Addendum No. 2

Date:	May 30, 2013
To:	Contractors
From:	Rick James - Project Manager
Reference:	George S. Eccles Student Life Center University of Utah – Salt Lake City, Utah DFCM Project No. 08015750
Subject:	**Addendum No. 2**

2.2 **GENERAL ITEMS**: See attached Architect's Addendum No. 1 dated May 28, 2013.

1 EP600 ONE-LINE DIAGRAM - 480V NORMAL POWER DISTRIBUTION

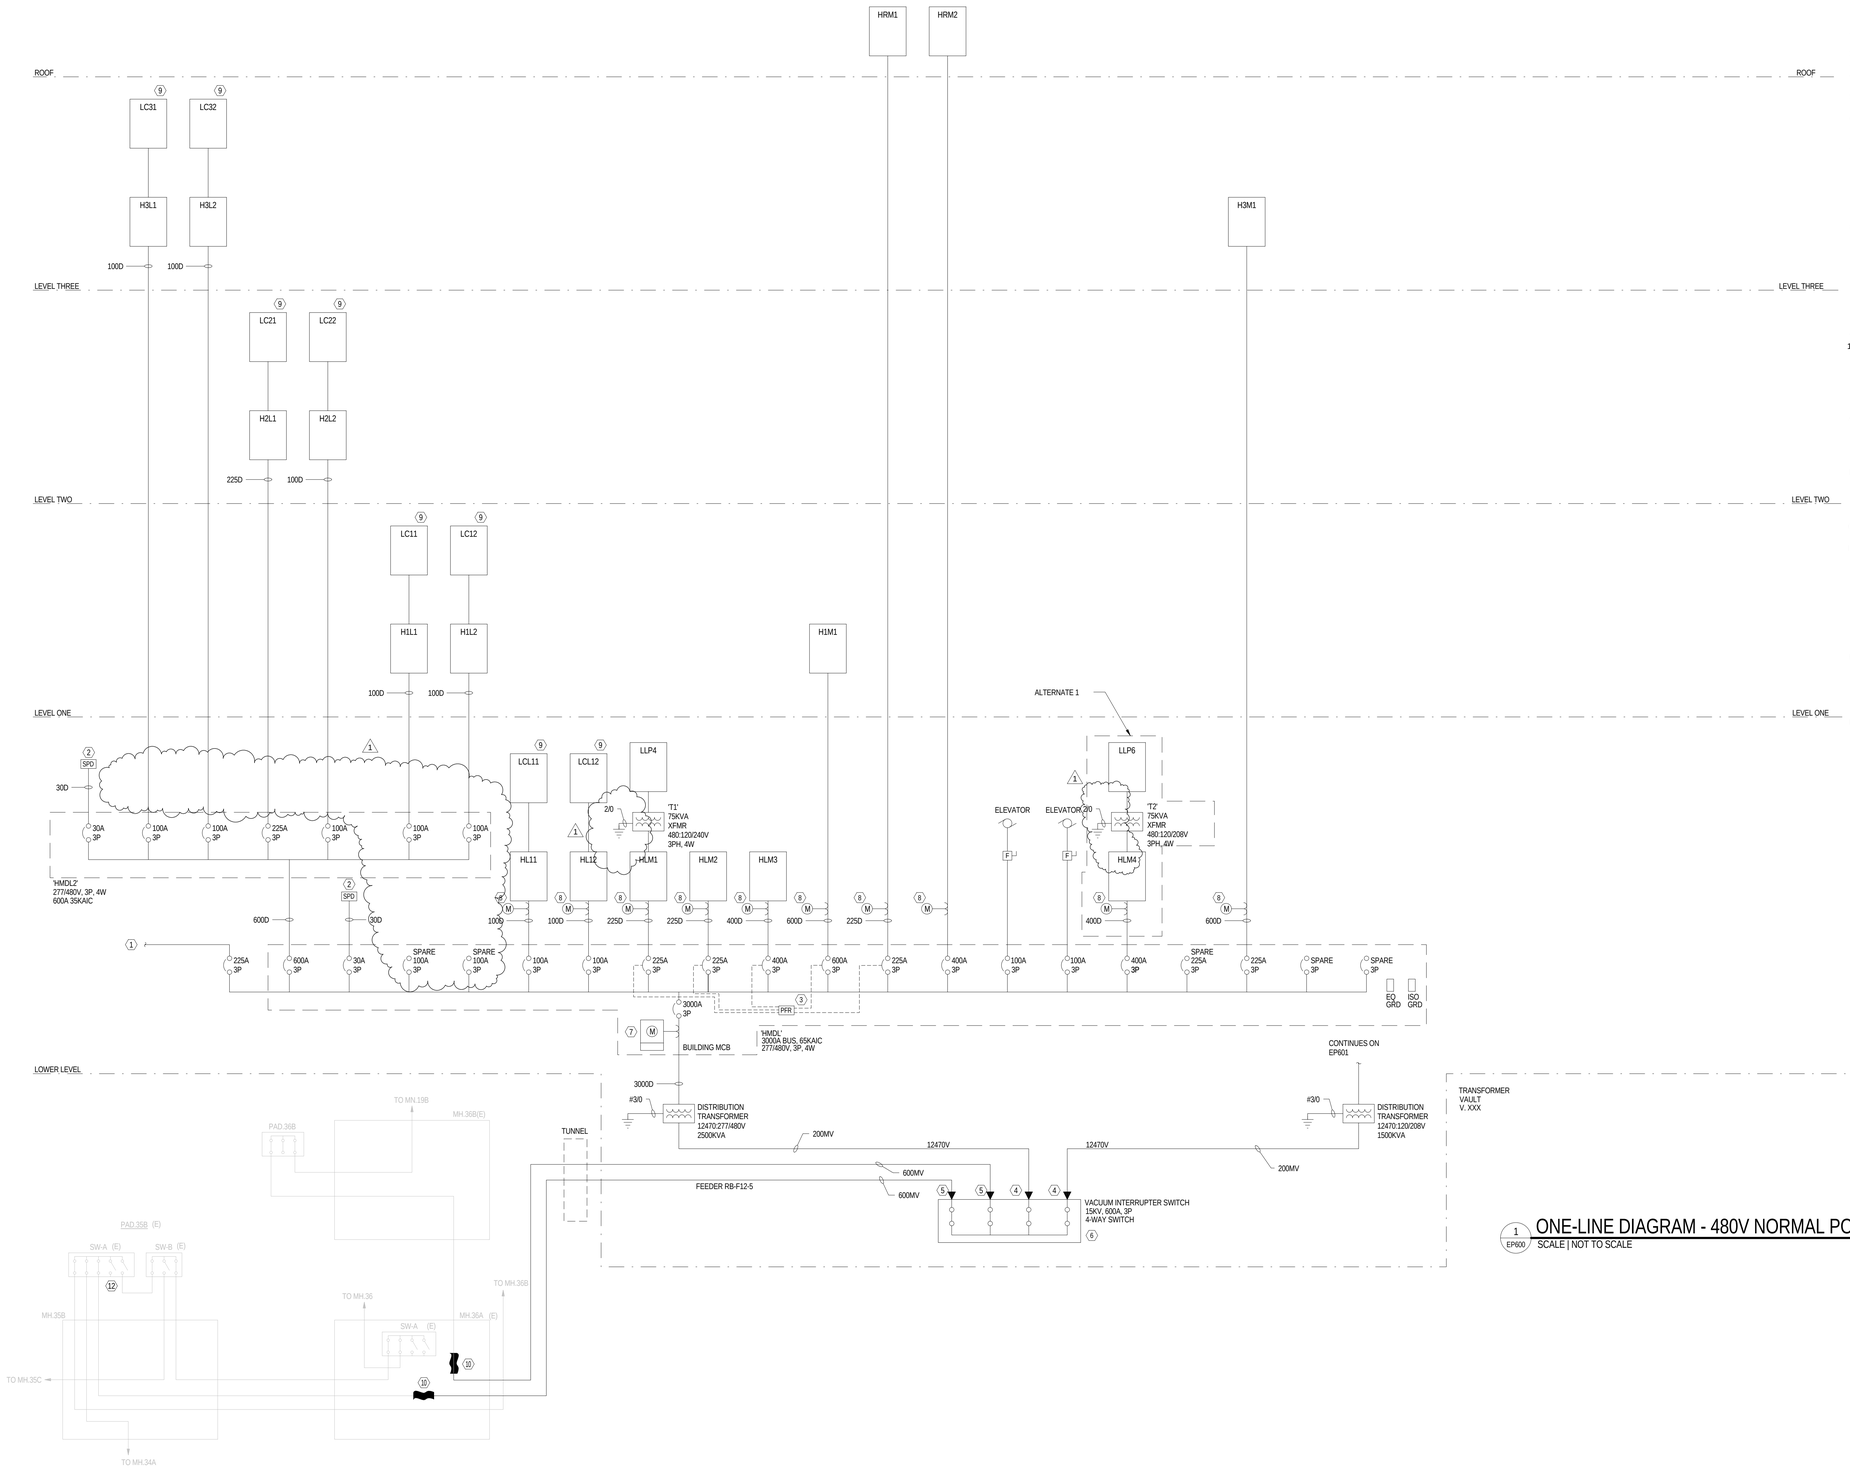
1. Change: Removed submeters from panels – see attached sheet EP600
2. Change: Moved Panels H1L1 and H1L2 with corresponding lighting control panels from panel HMDL to panel HMLD2.
3. Add: Added grounding to step down transformers T1 and T2.

1 ES100.2 ENLARGED ELECTRICAL SITE PLAN

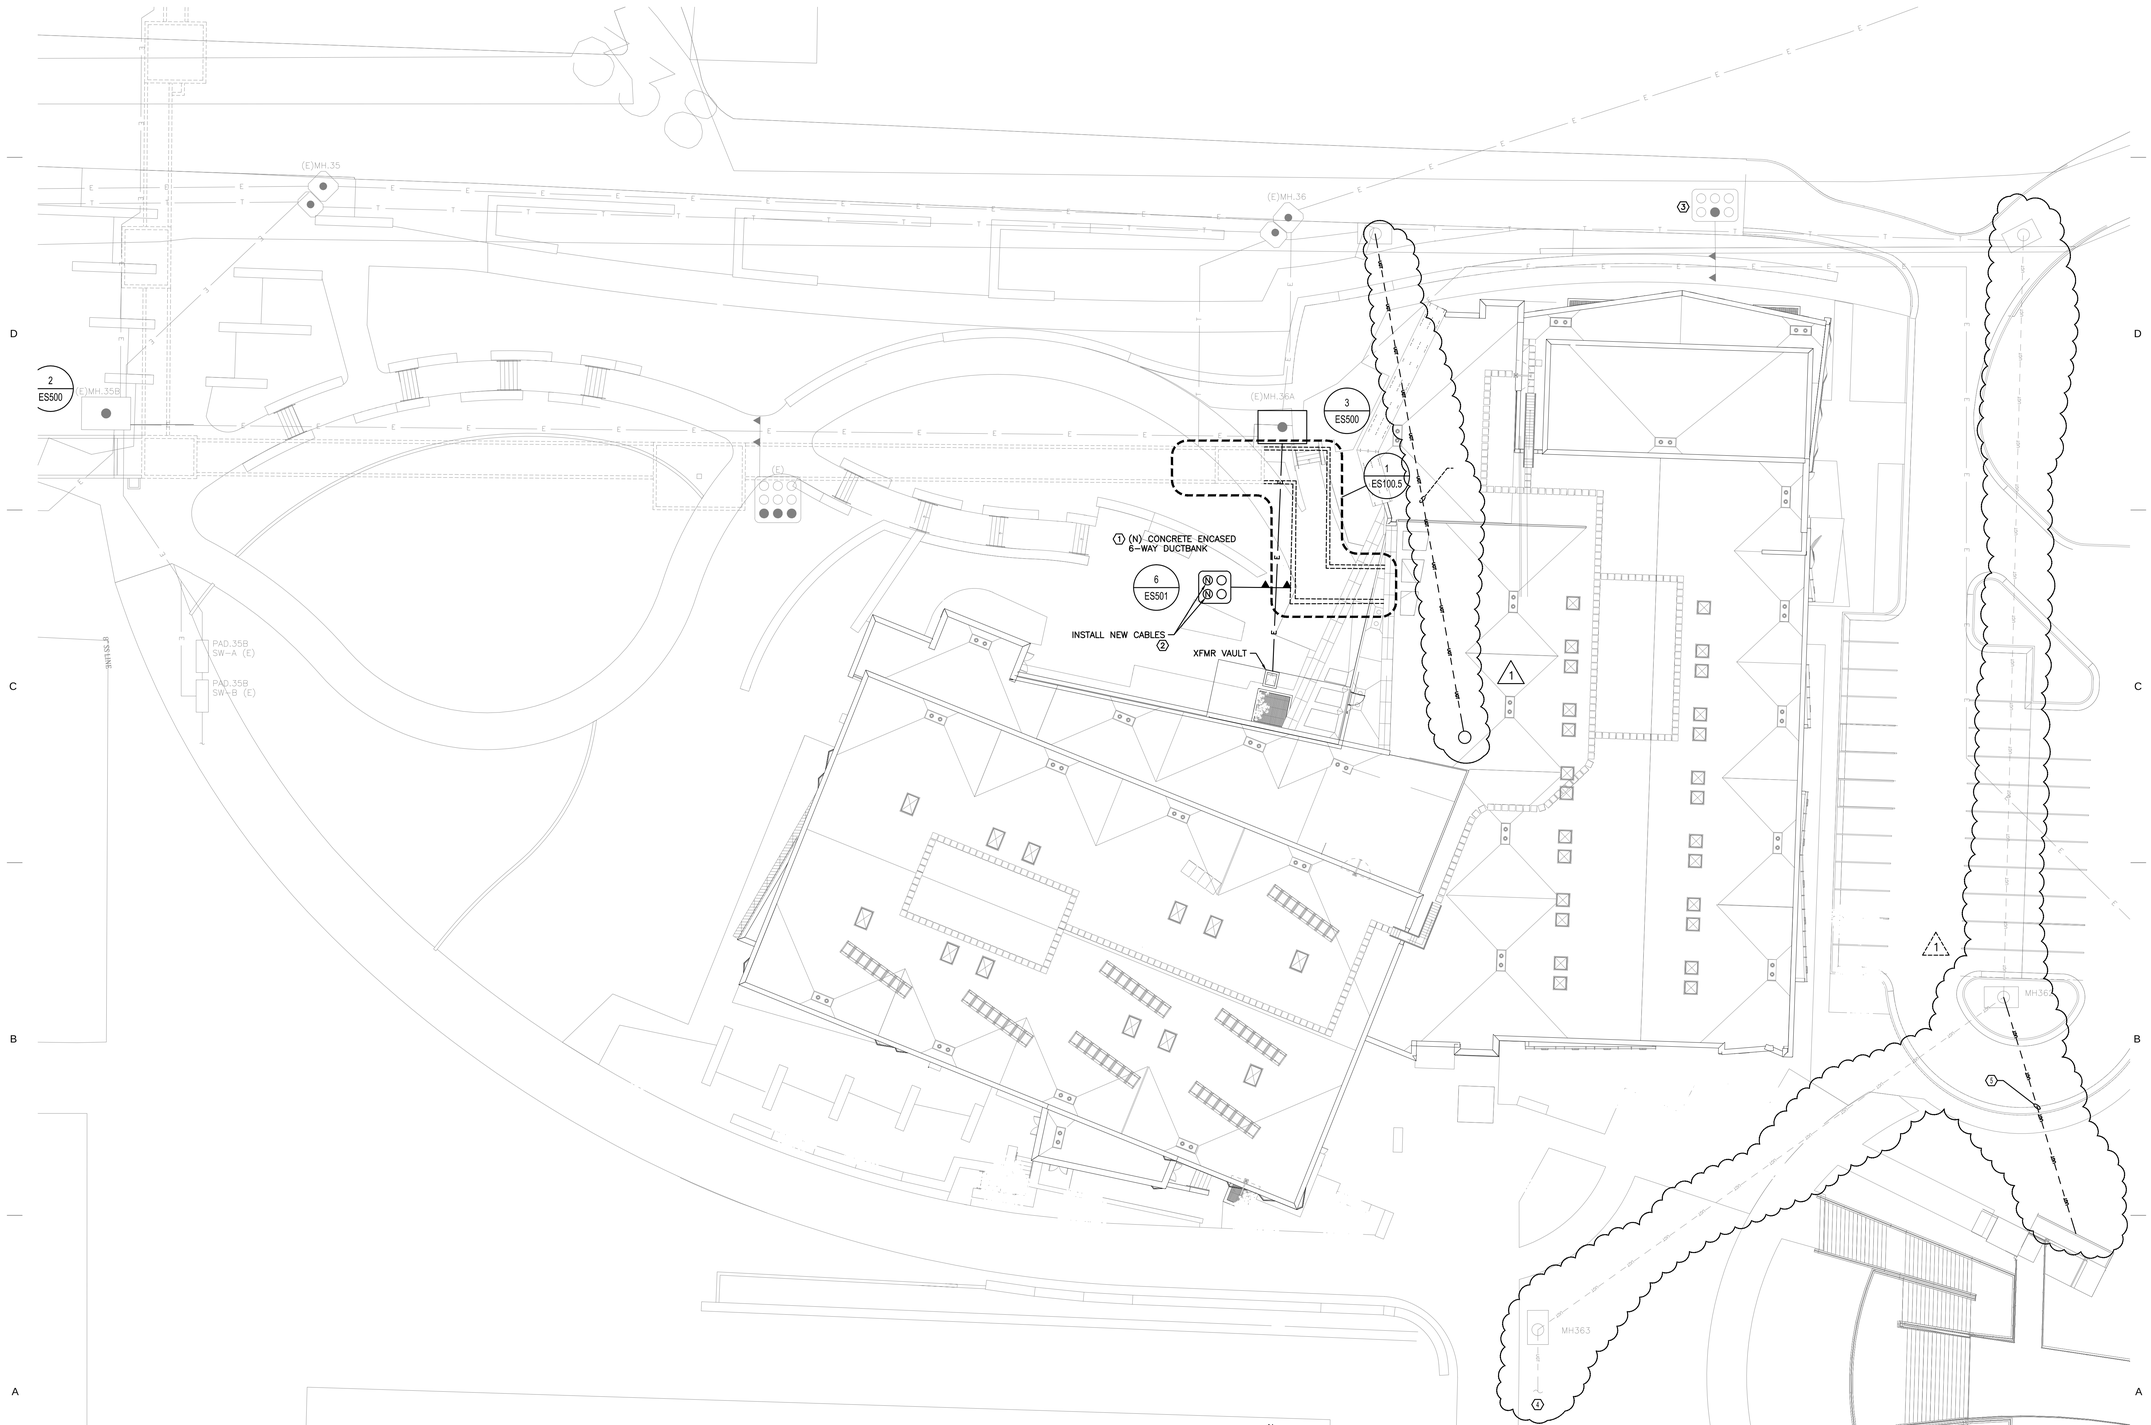
1. Add: Telecom routing from MH361 to main telecom room.
2. Add: Existing Routing and locations of telecom manholes and ductbank.
3. Add: Routing from MH362 to reefed telecom to existing bridge.
4. Add: Keyed Note #4 – See attached sheet ES100.2
5. Add: Keyed Note #5 - See attached sheet ES100.2

2 EY601 TELECOMM RISER DIAGRAM
SCALE | NOT TO SCALE

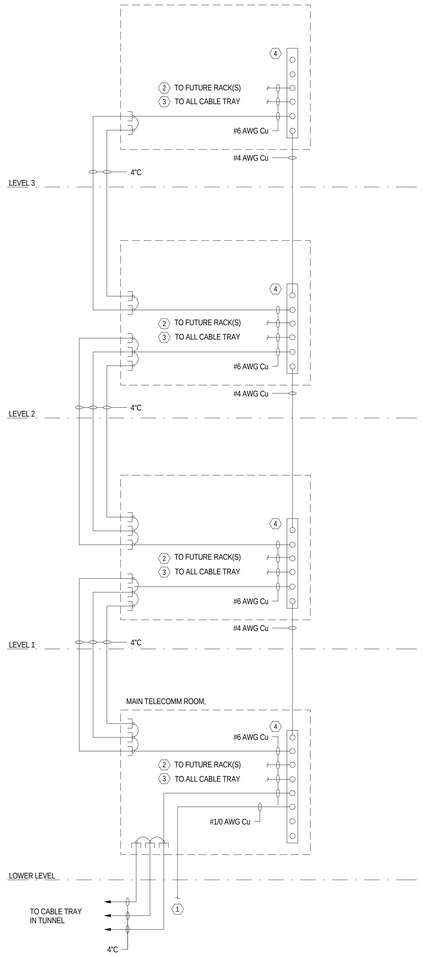
1. Change: Deleted Detail #1 Raceway and grounding riser diagram from sheet. Grounding is provided on sheet EY602.

POOL EQUIPMENT ROOM UNDERGROUND PIPING PLAN (ALTERNATE BID)

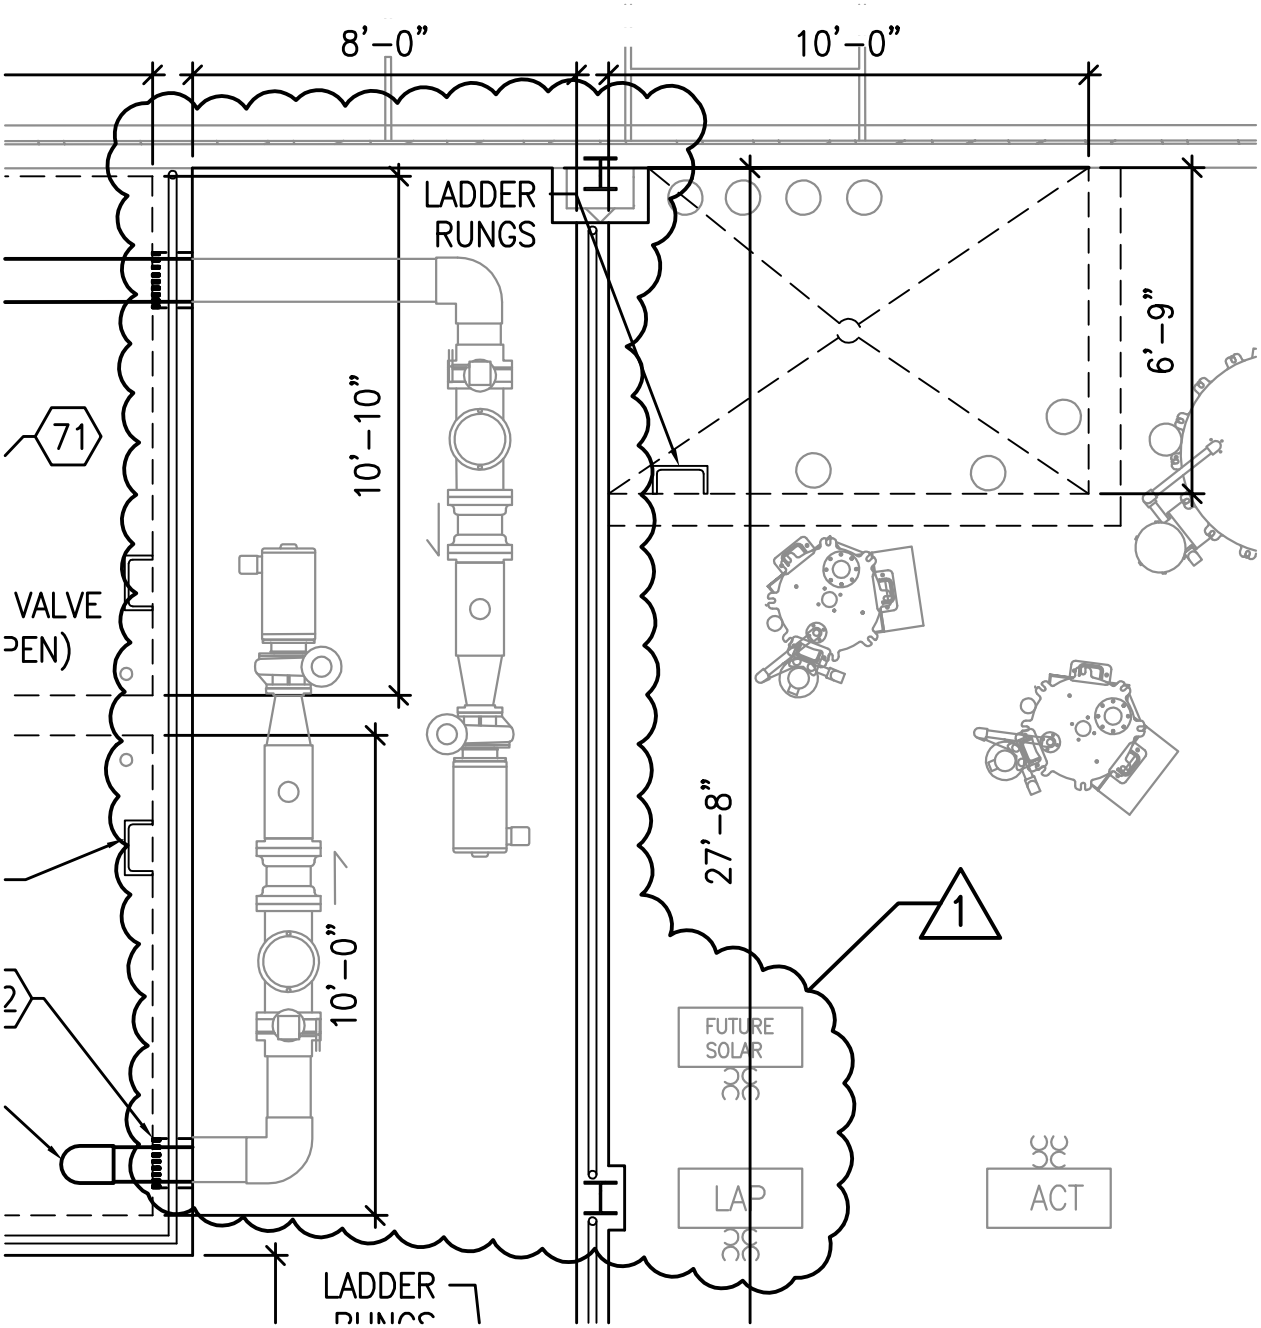
1. Pool Equipment Room Underground Piping Plan (Alternate Bid):
   a. Lap Pool and Activity Pool circulation pump locations revised to match as shown on WF407.0
   b. Solar Heat Exchanger and Lap Pool Heat Exchanger locations switched
   c. See attached AD01-WF12
2. Pool Equipment Room Circulation Face Piping Plan (Alternate Bid):
   a. Lap Pool and Activity Pool circulation pump locations revised to match as shown on WF407.0
   b. Piping associated with the above two pumps revised
   c. Lap Pool Heat Exchanger and FUTURE Solar Heat Exchanger and Lap Pool Heat Exchanger locations switched to accommodate better piping installation
   d. Piping associated with the above two heat exchangers revised
   e. 10" diameter by-pass valve and 10" capped tees added to the lap pool face piping for connection to the future solar heat exchanger.
   f. See attached AD01-WF13
